DRAINAGE TECHNICAL NOTE SITE B

DATE:	30 May 2023	CONFIDENTIALITY:	Public
SUBJECT:	Surface Water Drainage Strategy (Golf Course)		
PROJECT:	70088068 - Bognor Regis Golf Course	AUTHOR:	Chris Patmore
CHECKED:	Andy Smith	APPROVED:	Andy Smith

This note is in response to the comments raised by the Arun District Council Drainage Engineer (dated 10 March 2022, 30 September 2022 and 03 May 2023). For ease of reference the responses have been provided at Appendices D, E and F with commentary as to where each point has been addressed.

Figure 8 – Existing and Proposed West Field Drain routes

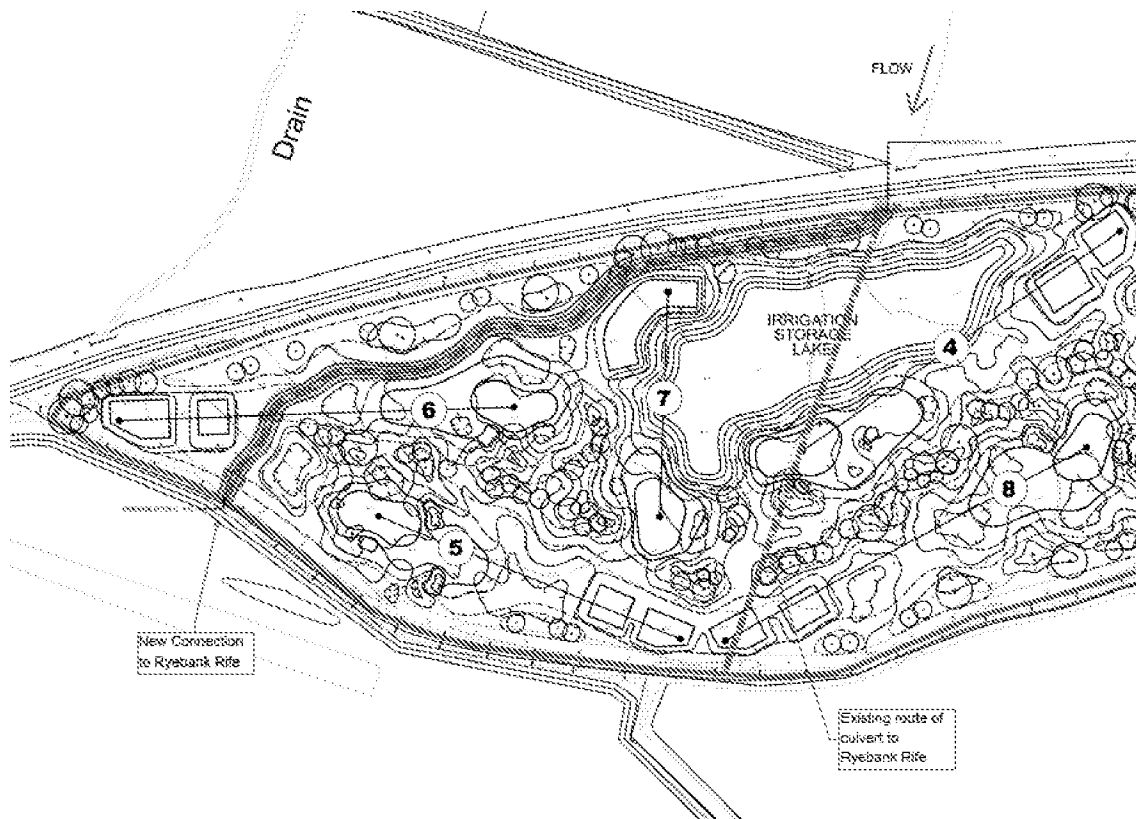
The current strategy outlines that run-off from the site will be restricted to greenfield rates to the existing watercourse but does not explore the opportunity for on-site infiltration. A Hierarchical approach to the disposal of surface water should be undertaken with priority to infiltration of surface water. Infiltration testing must be carried out to assess the opportunities for infiltration to ground. Winter infiltration testing is required to support infiltration drainage techniques and should be carried out in January/February (subject to agreement) and at agreed locations/depths/ Furthermore winter groundwater monitoring is required to support the basins designs and ensure there is no loss in attenuation capacity as a result of high groundwater levels.	Refer to Section 3.2
There is an existing culvert which runs through the site and would conflict with the locations of some of the ponds. It is also been advised that this existing culvert is blocked/collapsed. The drainage and site layout proposals will need to provide proposals for diverting this culvert and clearly demonstrating the route of this diversions with associated invert levels. We would encourage the applicant to investigate opportunities to open up this culvert to a watercourse as part of the diversion proposals.	Section 4.3

As part of the scheme, it is proposed to divert the route of the culverted section of the watercourse. In line with best practice, Environment Agency policy and following discussions with Arun District Council Drainage Engineer it is proposed that the section through the site is not only diverted to assist with the course layout and root protection zones, but that it is "daylighted" into an open watercourse. This can then be integrated into the scheme design along with providing improvements to the water environment, increased flood capacity, amenity and landscaping. The new route is also highlighted on **Figure 8**.
